40943R 17.1.91
With reference to G.O. No. 2177 dated
the 11th August 1890, I have the honor to submit
Revised Standard plans with quantities for
Sub Registrars offices with terrace & tile roofing,
prepared in communication with the
Inspector General of Registration

*Submitting plans &
quantities of Revised
standard designs for
Sub Registrars Offices.*

G.O. No 1320 W, dated 13th May 1891.

REVISED STANDARD DESIGN FOR A SUB REGISTRAR'S OFFICE
WITH TILED ROOFING

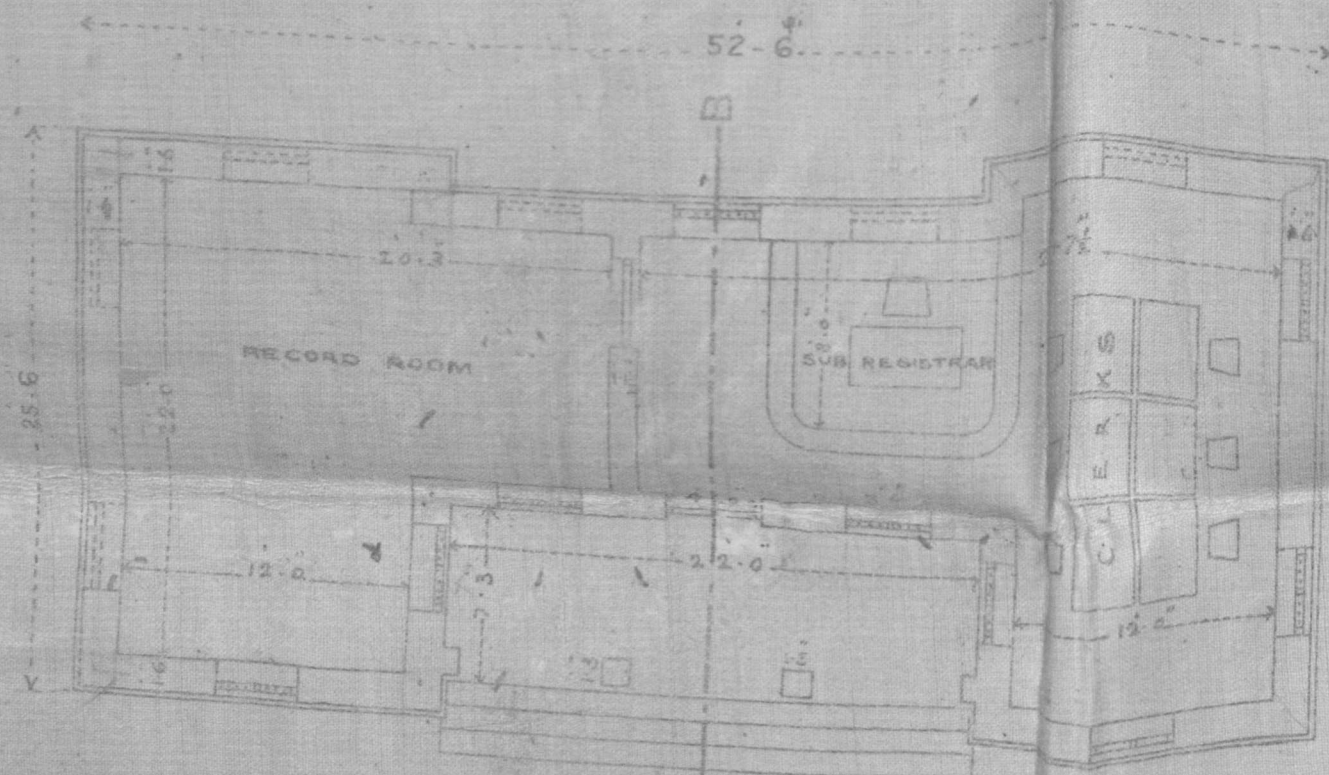
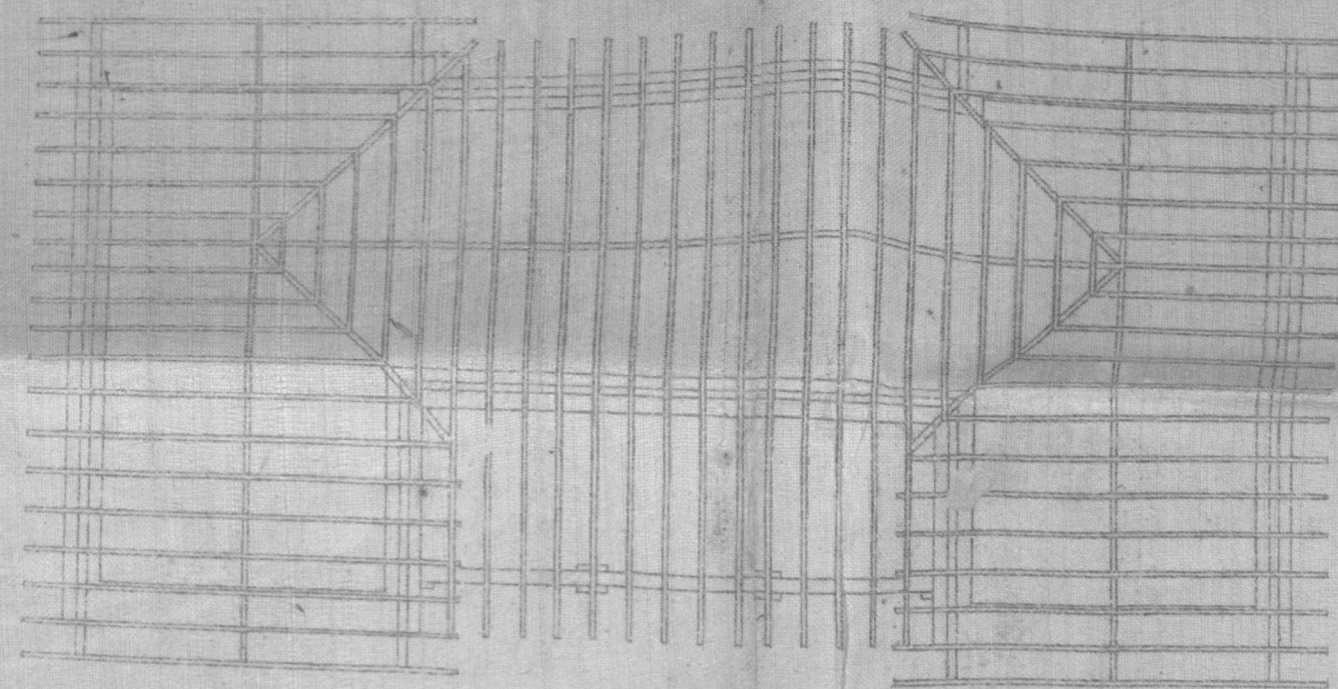
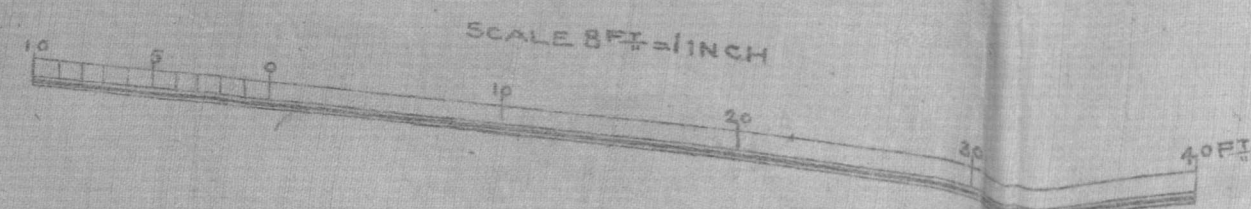
Adverting to Government reference dated 13th ult. on current No. 375 Judicial forwarding for my remarks revised standard designs for the larger Sub registry offices prepared by the Consulting Architect to Government, I have the honor to state that the accommodation provided is suitable and will meet requirements.

Adverting to the Government reference on No. 1081 dated 7 April 1891, I have the honor to state that the scheme for the transfer of records of the Sub Registrars' offices to the Registrars' offices will not obviate the necessity for providing increased accommodation in the larger sub offices as such increased accommodation is required on account of the large number of clerks which it has

been found necessary to employ of
late years owing to the rapid growth
of registrations. Moreover 20
years' records will always have
be retained in the sub-offices
and the space allowed for
records in the revised standard
plan now before Government
is not more than is required to
hold them, especially when it
is remembered that the records
of each year increase as com-
pared with those of the previous
year.

The revised type plan and quantities submitted by the Consulting Architects are approved for the Sub Registrars' offices, viz. those accommodating more than three clerks. In cases where the Establishment is smaller, the design circulated with G.O. 2230 W dated 21st July 1888 should be adopted.
